UNITED STATES PATENT AND TRADEMARK OFFICE

Office Action Summary	Application No. 10/508,406	Applicant(s) MATSUDA ET AL.	
	Examiner Nathan Danielsen	Art Unit 2627

DETAILED ACTION

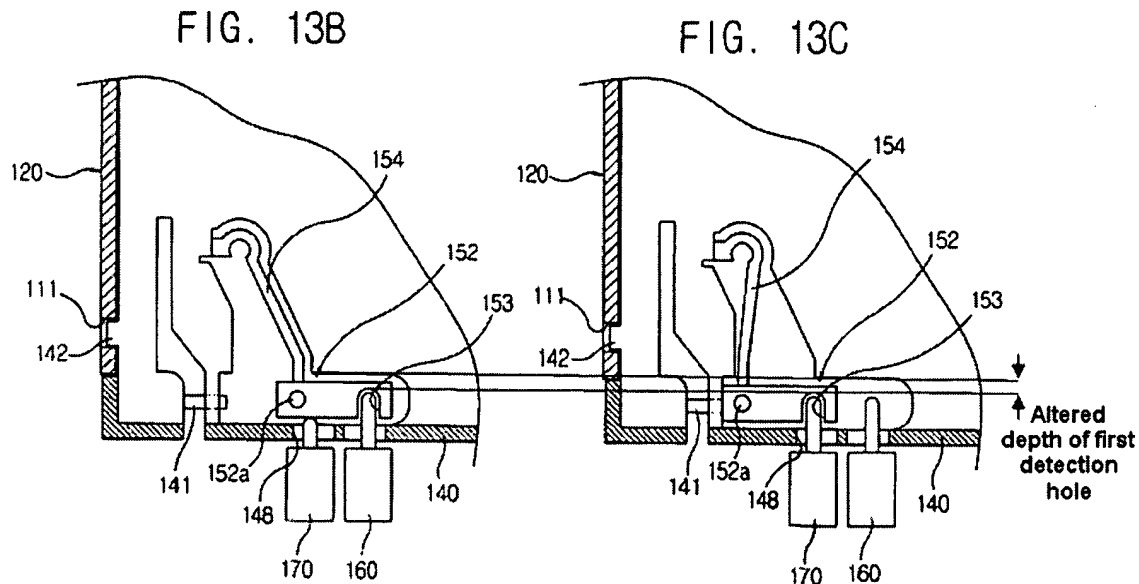
at least a first detection hole (A1 sensor hole 124 in figures 6, 12, and 13) and a second detection hole (A3 sensor hole 125 in figures 6, 12, and 13) formed at a predetermined position on a reference plane of said cartridge (figure 6); and

a slider (opening/closing member 152) configured to open and close said second detection hole (figure 13) and, when said detection hole is in a closed state, forming a plane substantially horizontal level with the reference plane of said cartridge at the position of said detection hole and said first detection hole is in an open state at all times once a tap is removed (figure 13),

wherein the slider includes a portion altering the depth of the first detection hole with respect to the reference plane upon closing said second detection hole (see figures 13B and 13C below).

However, Ko fails to disclose where the first detection hole is in an open state at all times.

In the same field of endeavor, the omission of an element and its function is obvious if the function of the element is not desired (see MPEP § 2144.04(II)(A)). Therefore, since the device of Ko meets the limitations of claim 1 with the removal of tap 124a and Applicant does not want the functionality of tap 124a, it would have been obvious to one of ordinary skill in the art at the time the invention was made to have removed tap 124a, for the purpose of not having an element causing the first detection hole to be in a closed state at any point in time.
